**Town of Duanesburg  
Planning Board Agenda  
July 21<sup>st</sup>, 2022**

**Re: Valley Mobile Home Court, LLC Project Review  
Subdivision, Site Plan and Special Use Permit  
Our Project No. 22438**

On July 7, 2022, PRIME AE received the Response Letter dated 7/7/2022, Revised Long Form Environmental Assessment Form (FEAF) revised 7/7/2022, Revised Site Layout Plans dated 7/7/2022, Subdivision Plan dated 7/7/2022 prepared by Empire Engineering, PLLC, and Stormwater Pollution Prevention Plan (SWPPP) dated 7/7/2022. This project, located at 6204 Duanesburg Road (tax map 055.00-4-11.151) on 106.2 +/- acres, proposes to subdivide the land into three (3) parcels and then construct 10 self-storage unit structures and 2 acres of impervious gravel storage area with associated driveway and stormwater management system. The minor subdivision portion of the project will create separate parcels for the existing barn and single-family dwelling from the proposed self-storage project parcel. Based on a review of the documents we provide the following comments (items in **bold** still need to be addressed):

EXISTING CONDITION MAP	
Date	7/7/2022
Scale	1"=100'
Sheet	21018
Project	V001
Drawn by	1 OF 8

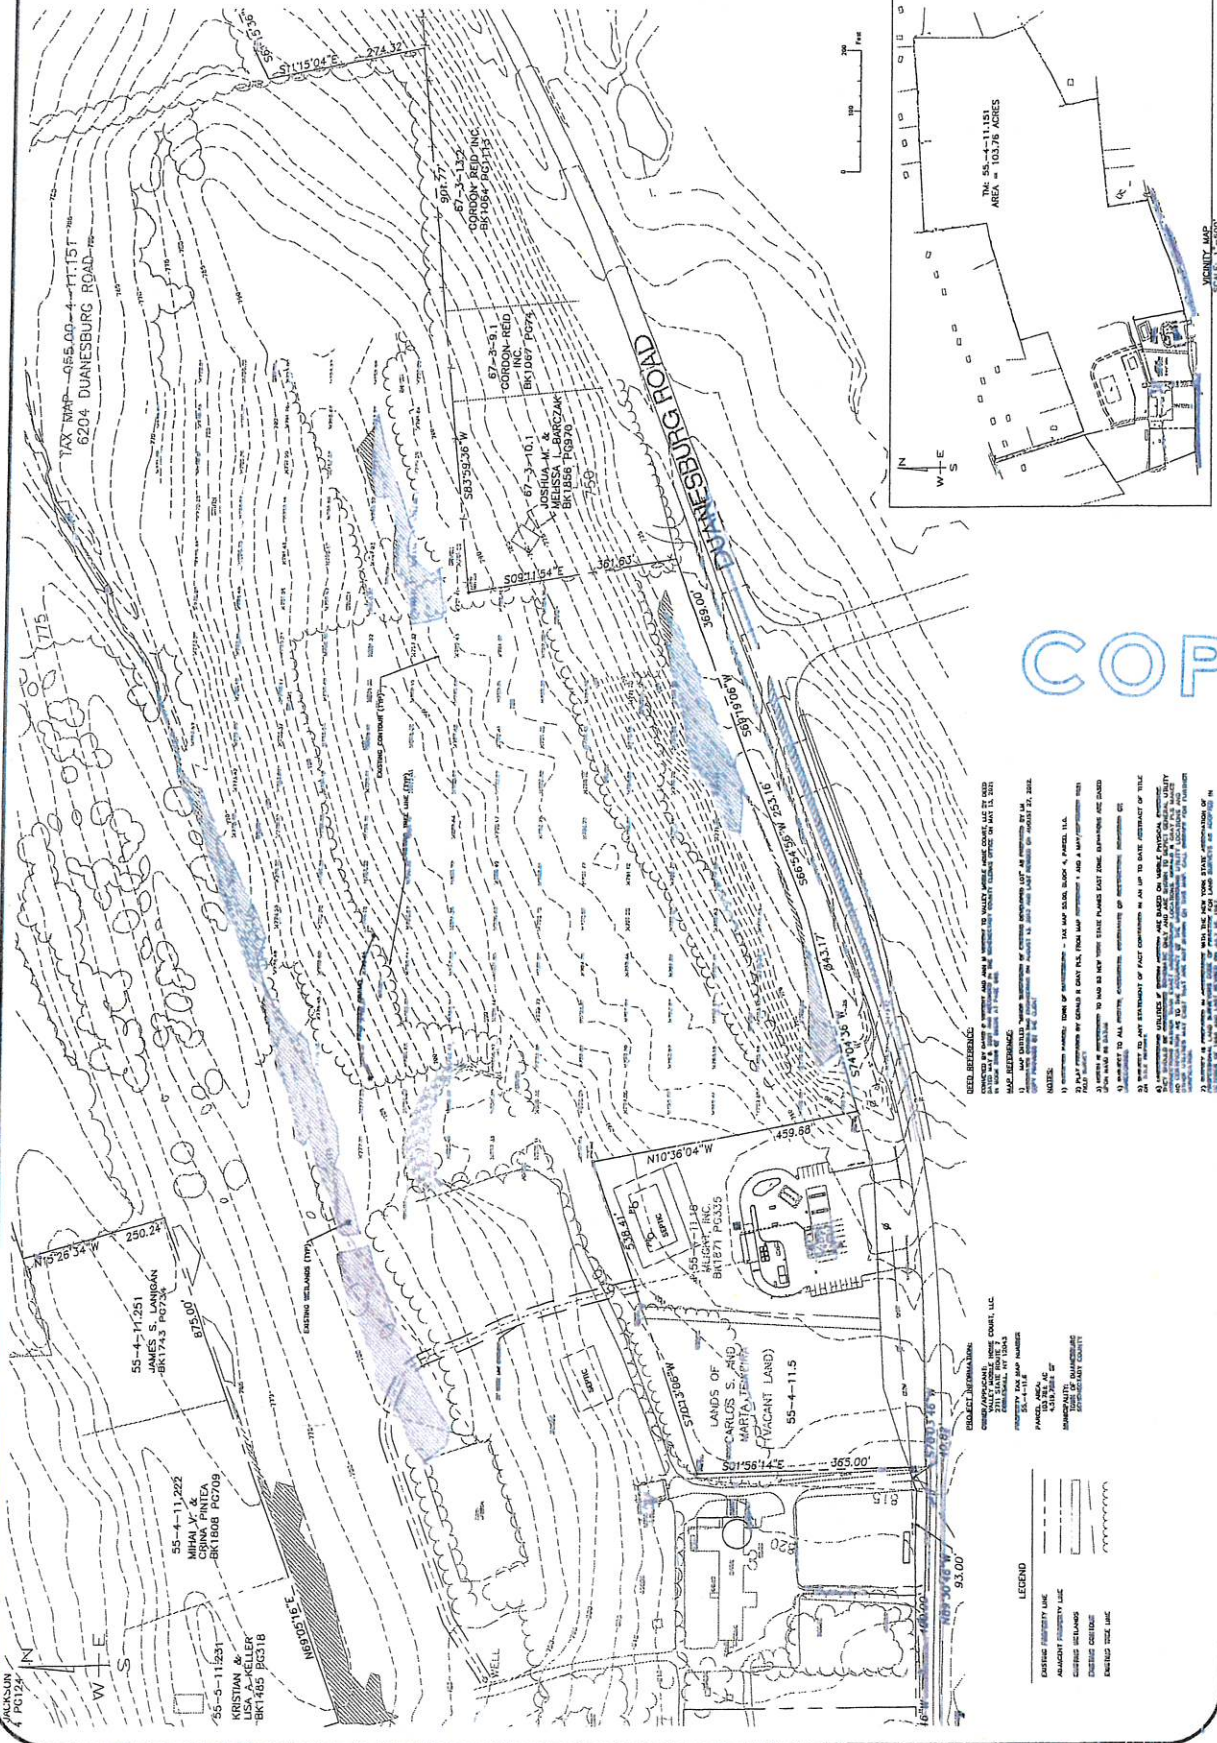
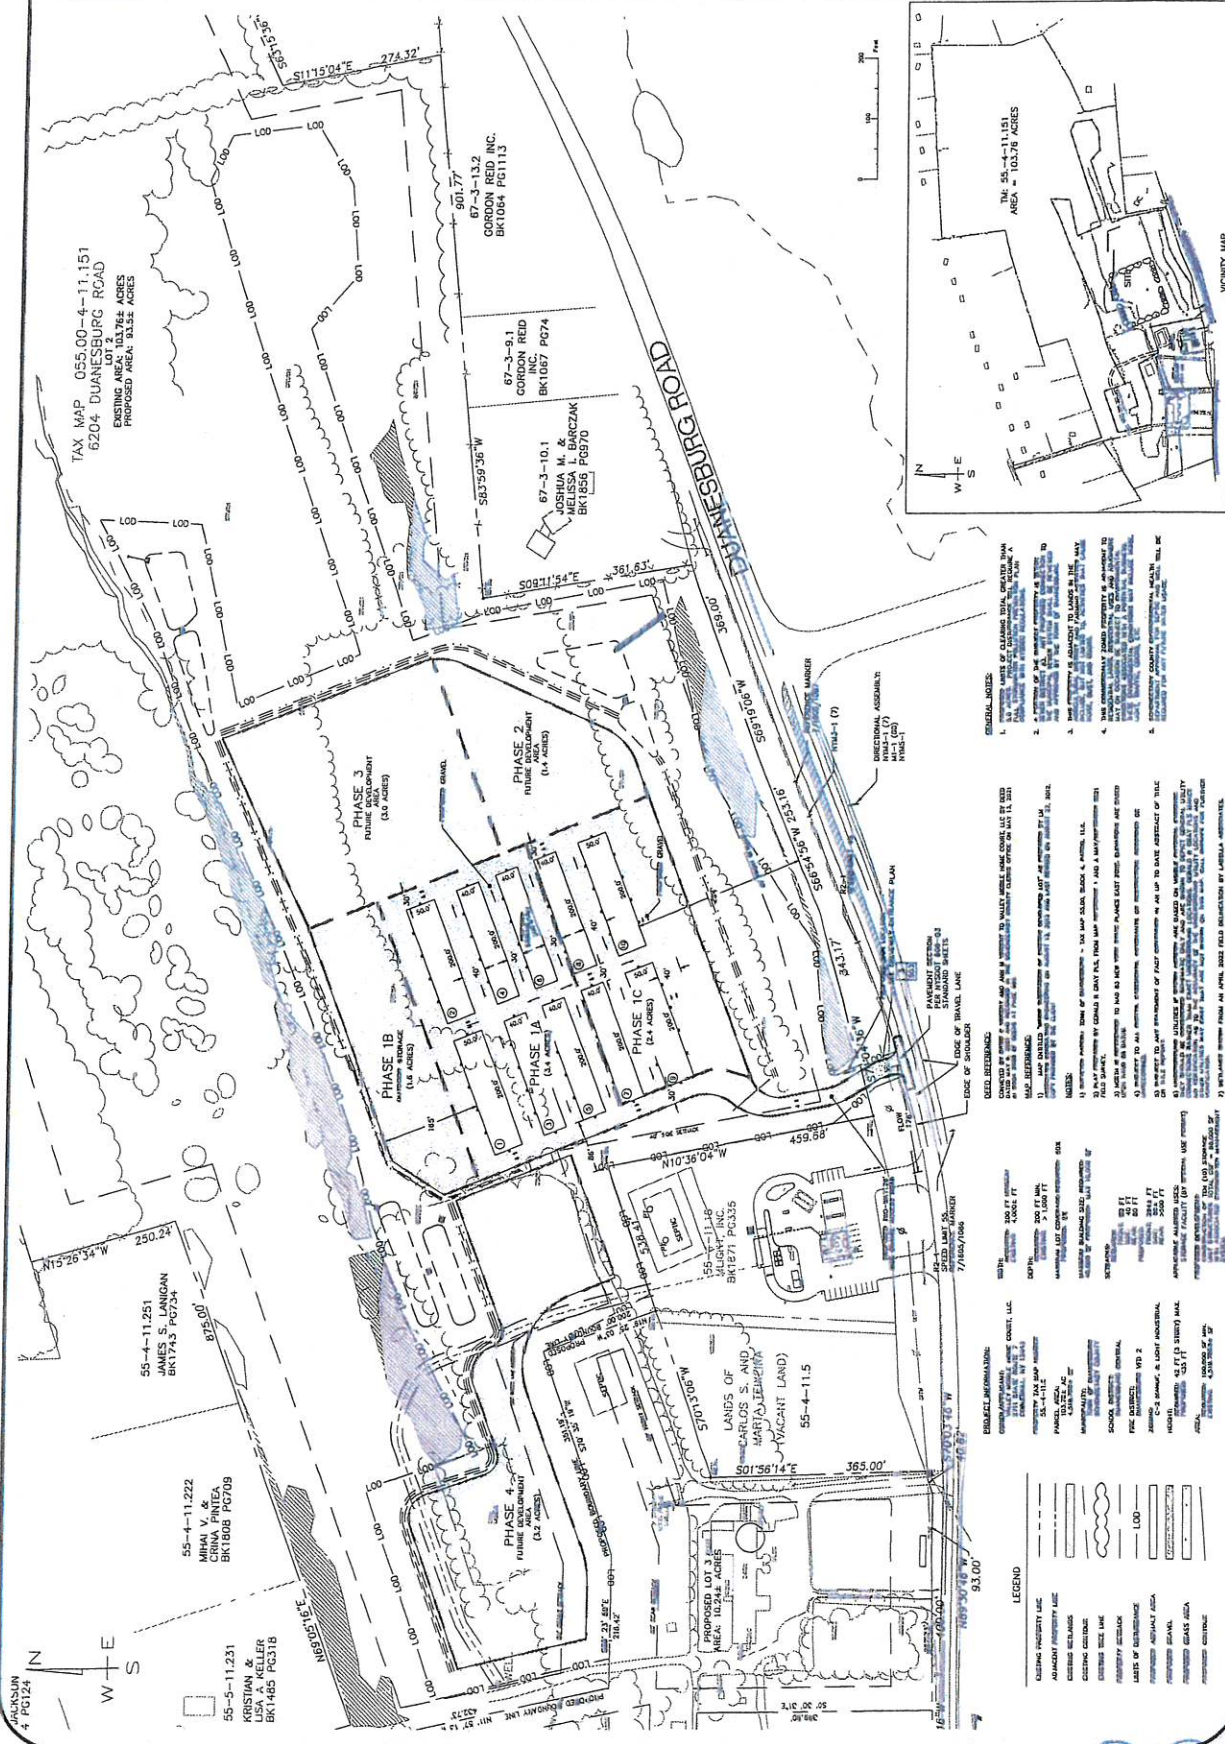
1. An Existing Conditions sheet has been added to the Drawing Set. The sheet shows the lot's existing contours, existing vegetation, watercourses, wetlands, flood plains, and bodies of water, structures, and all abutting lot landowner names and tax ID numbers, addressing our previous comment.

2. The location of the water bodies present at the location are now shown on the Existing Conditions Plan, satisfying our prior comment.
3. The Legend on Sheet C101 of the Site Plan now shows boxes of proposed asphalt, gravel, and grass with different shading; **however, no proposed grass areas appear to be shown on the Site Plan. The Applicant should indicate where grass areas are proposed on the Site Plan, if applicable.**

**An Existing Conditions Plan Sheet is now included in the set.**
2. In the FEEAF Part I Question E.2.h. the Applicant indicates there are lakes or ponds, and wetlands present on the proposed project site, however these have not been identified on the Site Plan. The Applicant should provide the location of the water bodies present at the location.

**The existing condition plan sheet now shows the existing conditions of a 'farm lagoon' pond which has since been filled. Also, all wetlands on-site are now shown, as delineated by Labella Associates in April 2022.**

DATE: 02/10/2022  
 SCALE: 1"=100'  
 SHEET: C105 OF 8

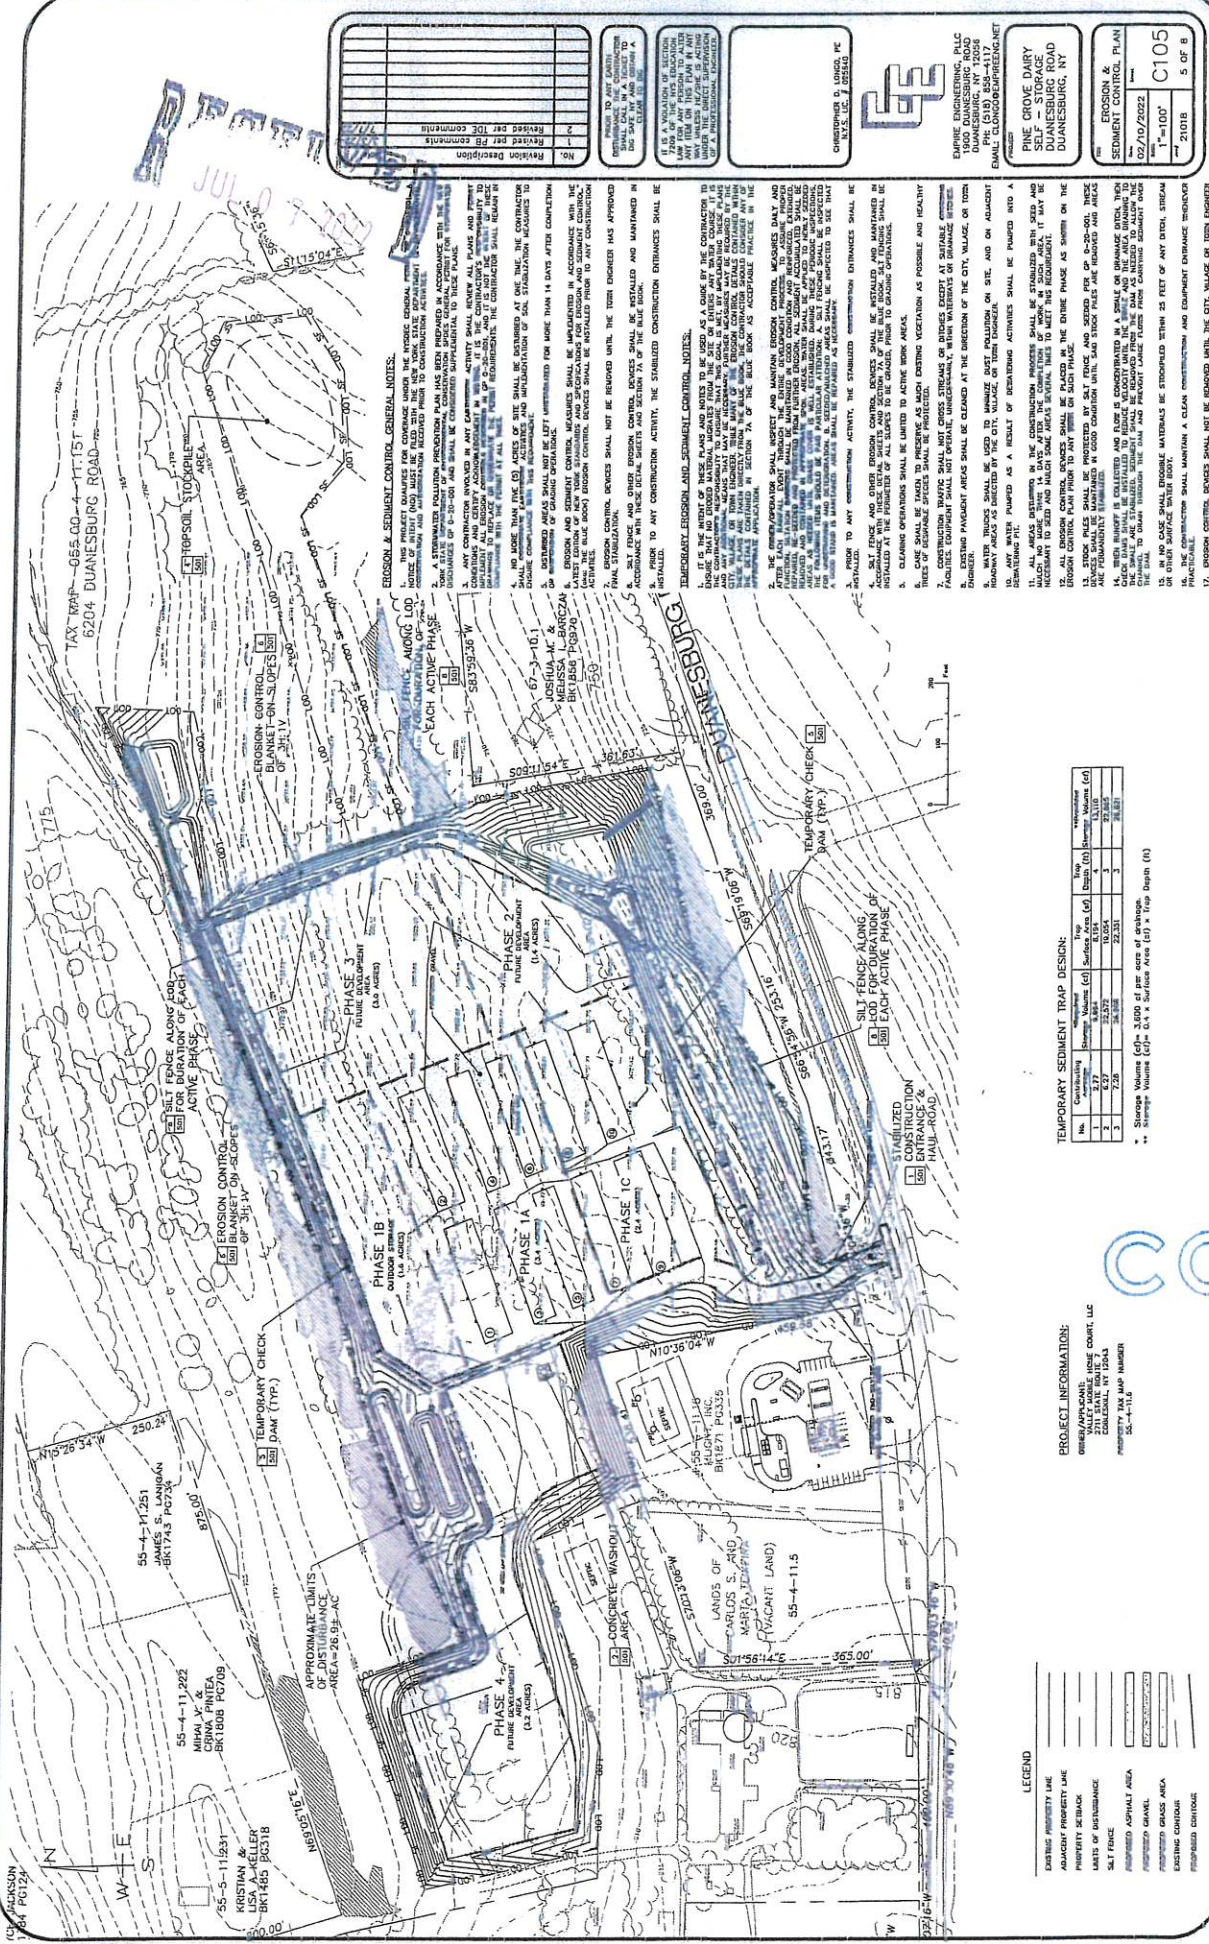
26. Empire Engineering has indicated in the comment response letter that the difference in acreage between the total area disturbed and the areas used for the hydraulic calculations is the total area of the stockpile area, which will be temporary. **The Applicant should show silt fence around the entire stockpile area to prevent the migration of soil laden runoff to areas outside the project site (the stockpile is at a higher elevation than the areas to the north, which are currently not shielded by silt fence on the proposed sediment and erosion control plan).**
